5Templewood Avenue Planning Application 2017/1229/P

Comments by Irving and Marion Yass 5a Templewood Avenue 18th April 2017

Objection to Planning Application 2017/1229/P - 5 Templewood Avenue

5 Templewood Avenue, Hampstead NW3 7UY Drawing ref 1046-10.04.17-3

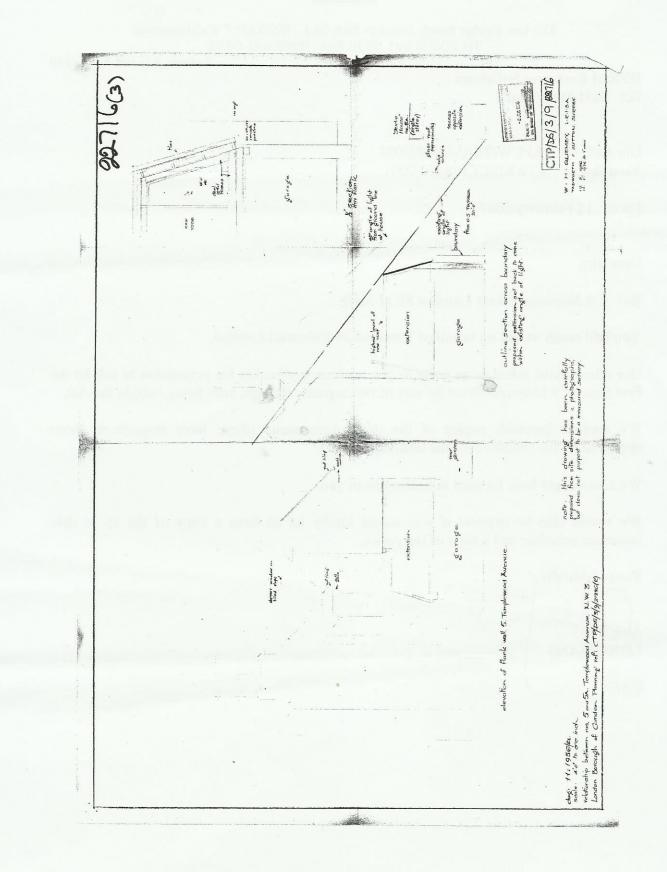
Our house is next door to 5 Templewood Avenue, having been built in what was formerly the garden of No 5. The attached plan, which has been provided by the Applicant's architect, shows the relationship between our house and No 5, including the proposed new side extension.

The position of the window in relation to the proposed new extension is shown on the attached plan. The distance between them, measured from this plan is about 6.5m. This window faces south west and allows afternoon sunlight into the room. The extension is 8m high, measured from the side elevation plan. It would block out the light and ruin the outlook. Although pre-application discussions have apparently been taking place for over a year, at no time did the applicant or the architect consult us. If they had taken the trouble to come to look at our house to inform themselves properly on the effect of the proposal on the amenity of the neighbours, the plans would surely not have proceeded this far in their present form. When the Applicant's architect, Jeremy Wight, did come to visit us on 13th April, he said that he would not now personally pursue the application in its present form, but it was for his client to decide.

Photograph of our patio, dining room and kitchen taken from close to the wall of the original garage block.

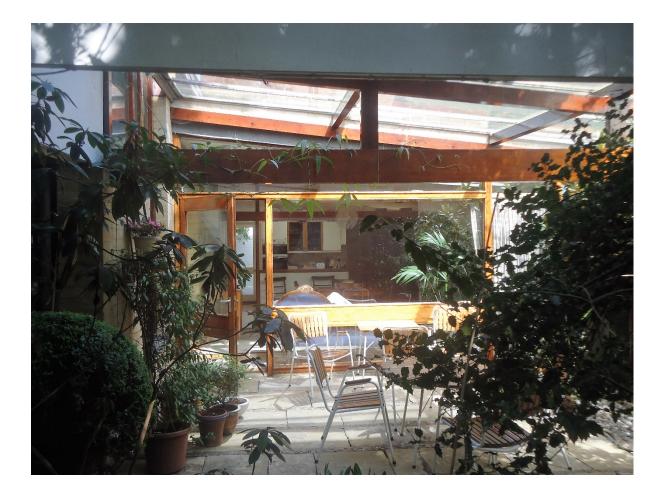
The proposed new extension will also take light from our dining room and patio. The window shown in the photograph below is the only source of light to our dining room, which also serves as the hallway giving access from the front door to the kitchen and living room. When the first floor extension was added to the original garage, the architect ensured that it did not take our light. The drawing at http://camdocs.camden.gov.uk/HPRMWebDrawer/Record/3414394/file/document

Photograph of our patio looking at the original garage block

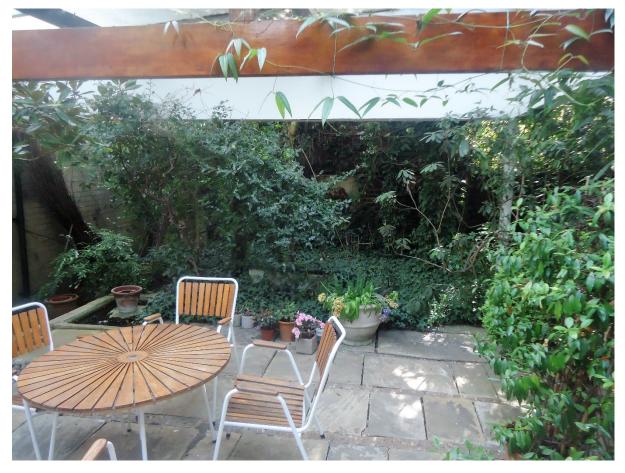
The relationship between our patio and the original garage block is shown in the photograph above and the one below.

Builders demolishing the side wall of the original garage block would effectively be working in the patio, depriving us of its use, with the interior of the house in full view through the window. Mr Wight agreed that it could be considered unacceptable.
